**NATIONAL RAILROAD PASSENGER CORPORATION
NORTHEAST CORRIDOR
NEW YORK - WASHINGTON
SUMMARY BULLETIN ORDER No. NYW1-24SUM
Effective 12:01 AM, Monday, January 5, 2026**

Northeast Corridor General Order: 103 effective November 3, 2025

New York - Washington Bulletin Order(s) in effect: NYW1-24SUM

G. PC: Between Lack and Hudson Interlocking

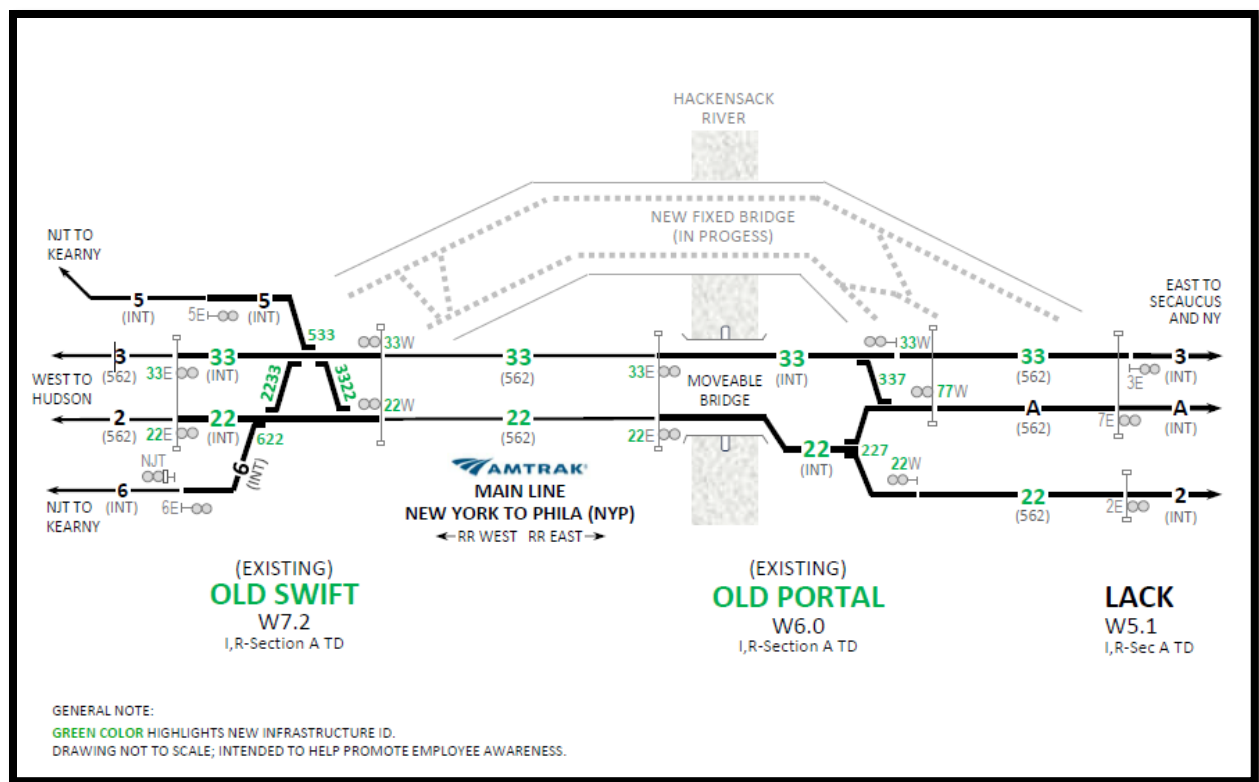
In conjunction with the installation of the Portal North Bridge, the following PC Changes are in effect:

1. Track Designation Changes

- No. 2 Track between Lack and the western limits of Old Swift is now designated as the No. 22 Track.
- No. 3 Track between Lack and the western limits of Old Swift is now designated as the No. 33 Track.

2. Old Portal Signal Designation Changes

- No. 2E Signal governing eastbound movements on No. 22 Track at Old Portal is now designated as the No. 22E Signal.
- No. 3E Signal governing eastbound movements on No. 33 Track at Old Portal is now designated as the No. 33E Signal.
- No. 3W Signal governing westbound movements on No. 33 Track at Old Portal is now designated as the No. 33W Signal.
- No. 2W Signal governing westbound movements on No. 22 Track at Old Portal is now designated as the No. 22W Signal.

3. Old Portal Switch Designation Changes

- No. 27 Switch at Old Portal is now designated as the No. 227 Switch.
- No. 37 Switch at Old Portal is now designated as the No. 337 Switch.

4. Old Swift Signal Designation Changes

- No. 2E signal governing eastbound movements on No. 22 Track at Old Swift is now designated as the No. 22E.
- No. 3E signal governing eastbound movements on No. 33 Track at Old Swift is now designated as the No. 33E.
- No. 2W signal governing westbound movements on No. 22 Track at Old Swift is now designated as the No. 22W.
- No. 3W signal governing eastbound movements on No. 33 Track at Old Swift is now designated as the No. 33W.

5. Old Swift Switch Designation Changes

- No. 23 Switch at Old Swift is now designated as the No. 2233 Switch.
- No. 32 Switch at Old Swift is now designated as the No. 3322 Switch.
- No. 53 Switch at Old Swift is now designated as the No. 533 Switch.
- No. 62 Switch at Old Swift is now designated as the No. 622 Switch.

K. 277-N3. Non-Conforming Aspect: Old Portal to Old Swift

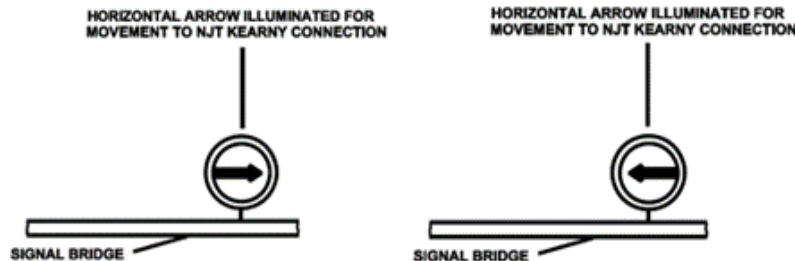
277-N3 is renamed. Non-conforming Aspect: Old Portal to Old Swift.

No. 2 & 3 Trks are modified to No. 22 & 33 Trks.

White directional indicator arrows in service for westward movements on No. 22 and No. 33 tracks at MP 6.3 and home signals at Swift.

- When route at Old Swift is lined for diverging movement to NJT Kearny Connection from No. 22 track to No. 6 track or from No. 33 track to No. 5 track, directional indicator arrows will display at both Old Swift and MP 6.3.
- When route at Old Swift is lined for diverging movement to NJT Kearny Connection from No. 22 track to No. 5 track or from No. 33 track to No. 6 track, directional indicator arrow will display at Old Swift, but will not display at MP 6.3.

Trains receiving route indication not proper for train's destination must stop east of Old Swift Interlocking and contact the Section A Dispatcher for instructions.
